Brookleigh, Northern Arc

Stage 1 Road Safety Audit - ADDENDUM
Northern Arc Avenue and Diversion of Cuckfield Road
(B2036)

Project number: 60610807
60610807-ACM-CS-XX-RP-HW-0008
December 2025

Figure B-1. Locations of Problems (RSA Addendum Brief Page 8)

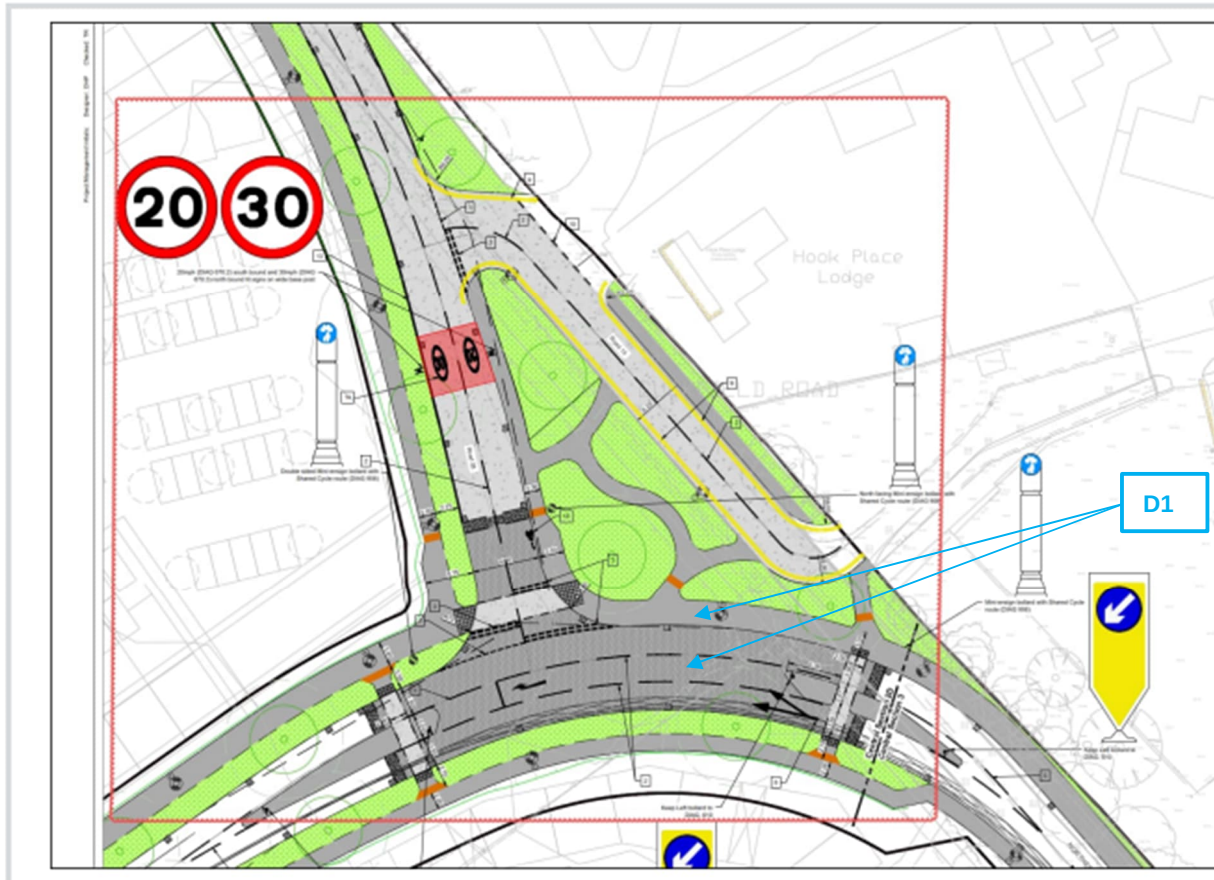
B1 PROBLEM

Location: Proposed chicane arrangement on Cuckfield Road

Summary: Larger vehicles may collide with infrastructure/ kerb or verge when navigating chicane layout.

A chicane layout is proposed on Cuckfield Road. The swept path analysis provided shows that an articulated vehicle appears to overrun / overhang the verge when navigating the arrangement. In addition, it is understood that the route is regularly used by other large vehicles (e.g. agricultural vehicles) and it is unclear whether all vehicles using the route would be able to do so safely. This may result in larger vehicles colliding with the chicane build-outs, verge and/ or losing control at this location.

B2 PROBLEM

Location: Proposed chicane arrangement on Cuckfield Road

Summary: Road users may struggle to safely egress the private driveway opposite the chicane arrangement, potentially resulting in collisions with other road users.

Road users egressing the private (angled) driveway on the western side of Cuckfield Road, located opposite the northern chicane buildout, may struggle to safely manoeuvre out of the access when southbound road users are queuing at the chicane arrangement give-way line. It is unclear whether swept path analysis has been undertaken of this movement, however road users turning at this location may collide with queuing traffic and/ or other vehicles on Cuckfield Road, especially if they are required to undertake slow, point turns for example.

It is recommended that the layout is revised to ensure that the scheme can be safely navigated by all vehicles that will use it.

It is recommended that swept path analysis is undertaken to ensure that road users can safely manoeuvre in and out of the driveway without issue.

Figure B-2. Locations of Problems (RSA Addendum Brief Page 8)

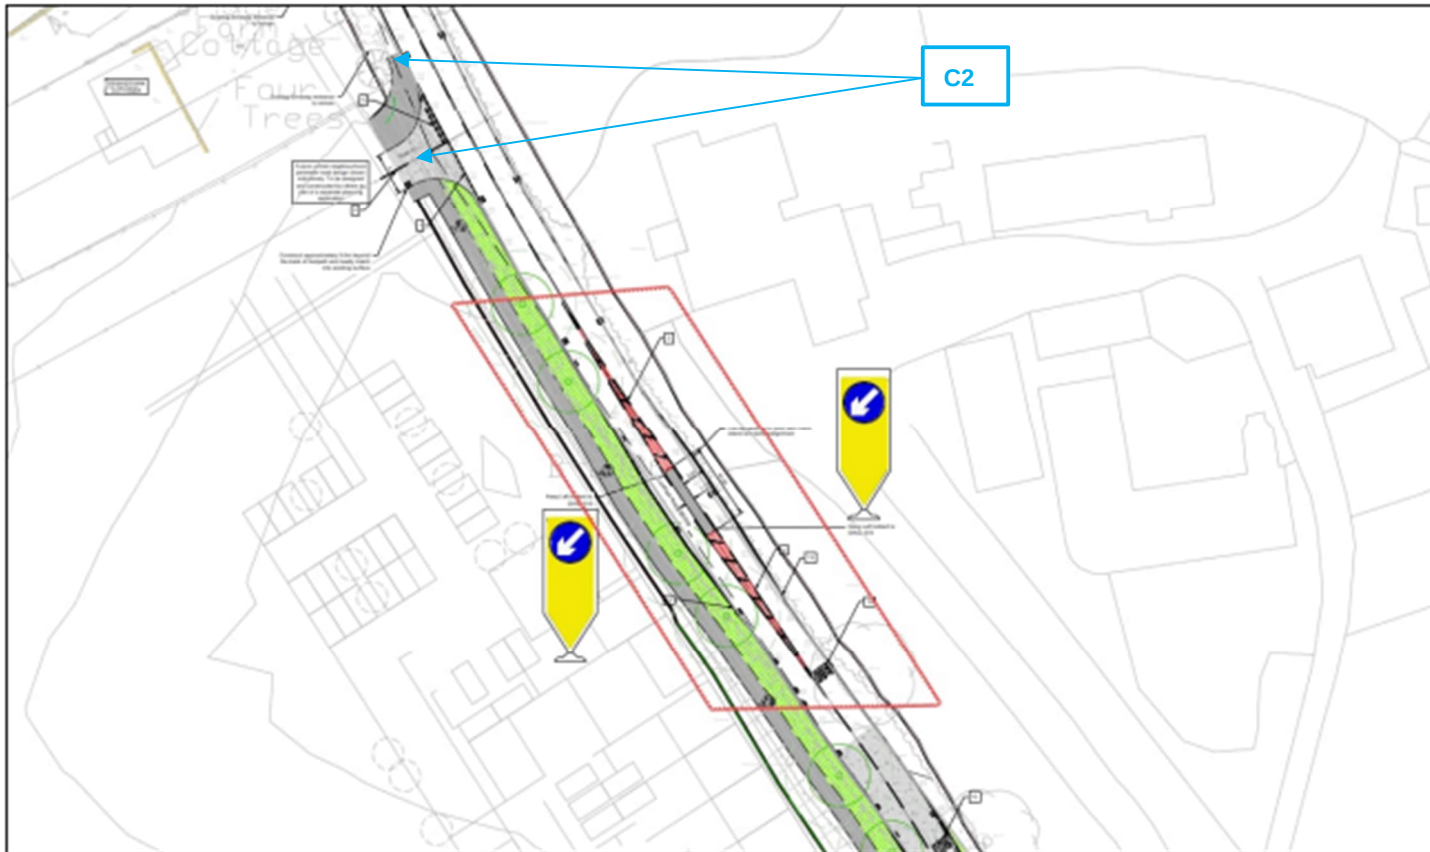
C1 PROBLEM

Location: Northern Arc Avenue/ Road 09 Junction (southern footway, west of junction)

Summary: Confusion resulting from unclear messaging regarding the type of provision/ facility at this location may result in footway user/ cyclist collisions.

The north/ south running section (along Road 09) of the Green Super Highway terminates just south of the junction with Northern Arc Avenue. The section of footway (or potential shared cycleway) west from this point, running along the southern side of Northern Arc Avenue as far as the pedestrian crossing, includes/ features the following:

- A 3m wide facility
- Numerous sets of corduroy paving
- Cyclist dismount signage/ Segregated shared use signage
- An angled area of paving with a dropped kerb onto the carriageway (assumed to be for cyclists joining the carriageway)

Some elements of the layout in this area, such as the 3m width and the angled section of paving/ dropped kerb suggests that this is a shared facility, however the presence of the corduroy paving and cyclist dismount signage suggest it is footway only. This may cause confusion to users resulting in collisions between footway users (especially those with visual impairments) and cyclists.

It is recommended that the design is amended so that the type of provision at this location is clear to all users.

Figure B-3. Locations of Problems (RSA Addendum Brief Page 9)

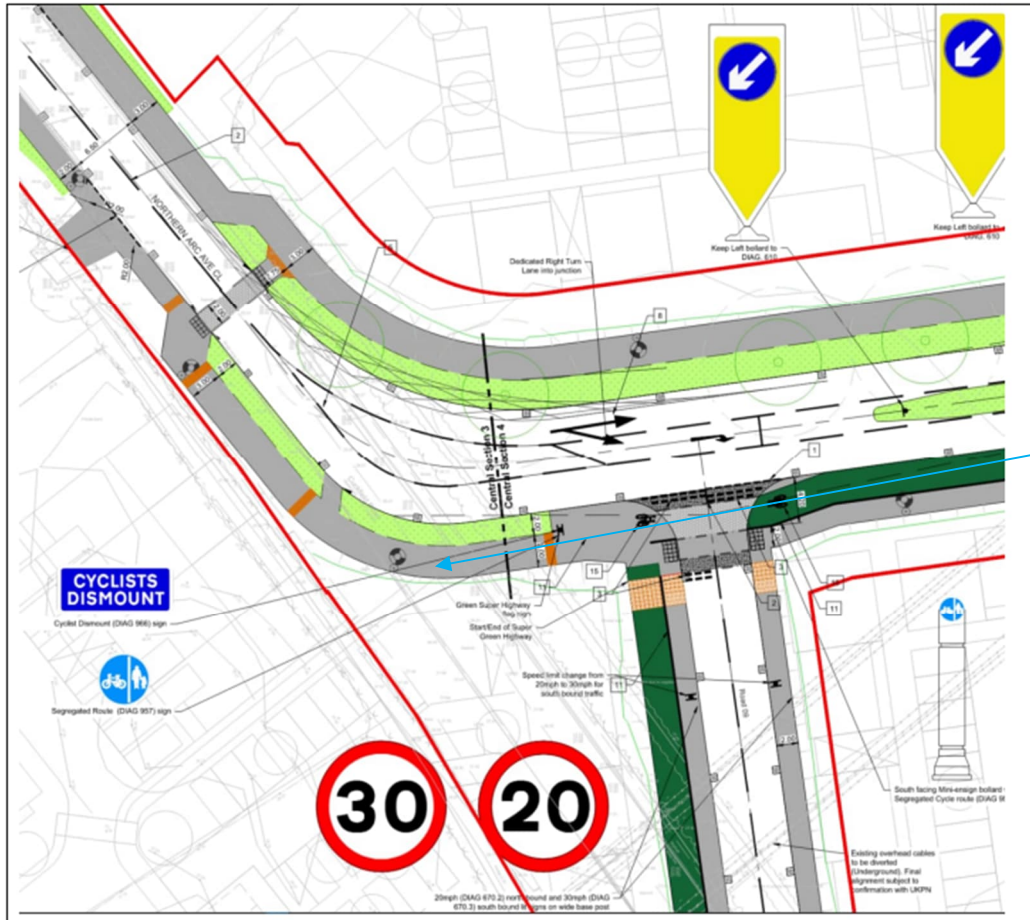
C2 PROBLEM

Location: Cuckfield Road/ Road 5 Junction

Summary: Absence of pedestrian crossing facility and onward pedestrian facilities may result in pedestrians being struck by passing road users.

There does not appear to be a pedestrian crossing facility across Road 05 at its junction with Cuckfield Road despite there being footway provision on both sides at this location. In addition, the footway provision on the northern side of the junction consists of a small spur, which does not appear to connect to anything else (i.e. existing or proposed footway provision running north). The absence of a suitable crossing facility and/ or onward footway provision to the north may result in pedestrians attempting to cross at unsuitable locations and/ or walking in the carriageway where they will be at risk of being struck by passing vehicles.

It is recommended that a pedestrian crossing is provided across the Road 05 junction and onward pedestrian facilities are provided north of the junction, as required.

Figure B-4. Locations of Problems (RSA Addendum Brief Page 10)

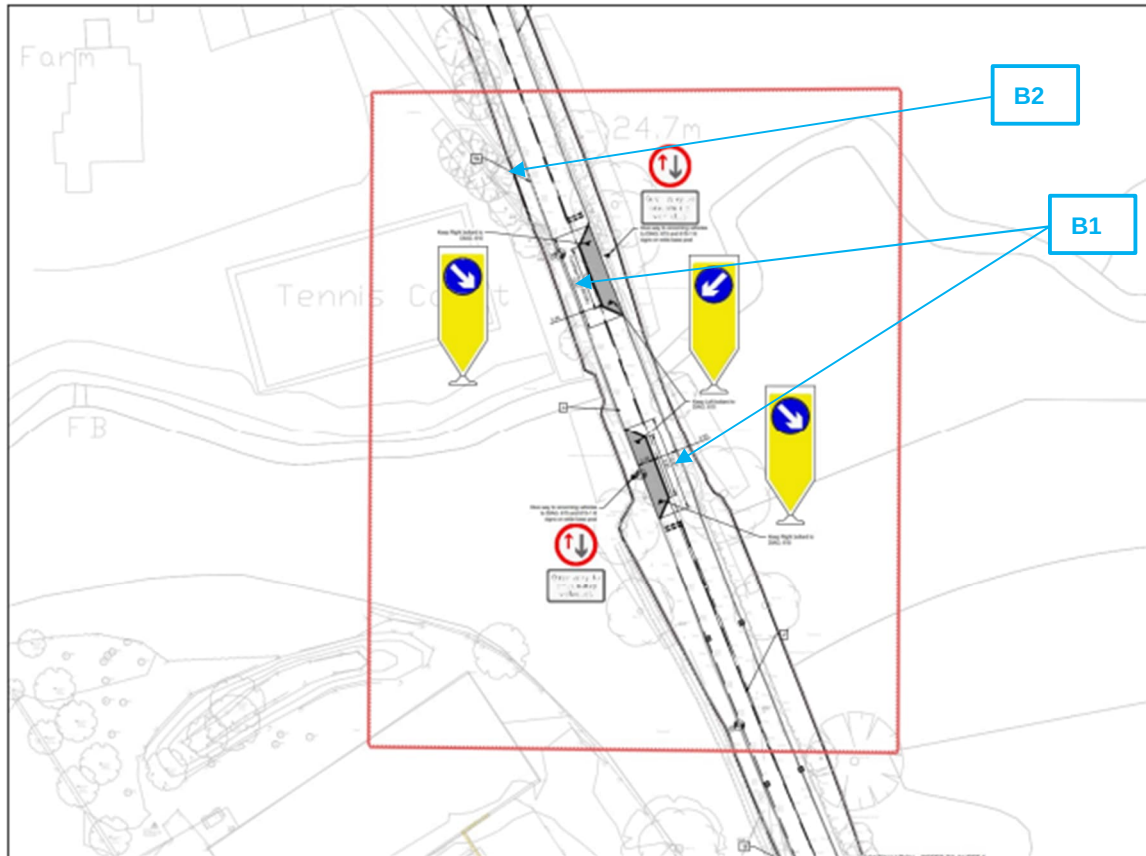
D1 **PROBLEM**

Location: Northern Arc Avenue/ Cuckfield Road (North) Junction

Summary: Insufficient differentiation between the footway and carriageway may result in road users overrunning the footway area or footway users inadvertently entering the live carriageway; this could result in collisions between road users and footway users.

A raised table is proposed at the Northern Arc Avenue/ Cuckfield Road (North) junction. It is unclear from the information provided whether there will be any level difference and/ or sufficient colour contrast/ differentiation between the proposed carriageway and footway surfacing through this section. Inadequate differentiation may result in road users mistakenly encroaching/ overrunning the adjacent footway area, especially given the horizontal alignment through the junction. Similarly, footway users (particularly those with visual impairments) may inadvertently enter the live carriageway. Collisions between road users and footway users could occur as a result.

It is recommended that care is taken at detailed design stage to ensure sufficient contrast/ delineation (colour/ surfacing/ height) is provided between the carriageway and footway areas.
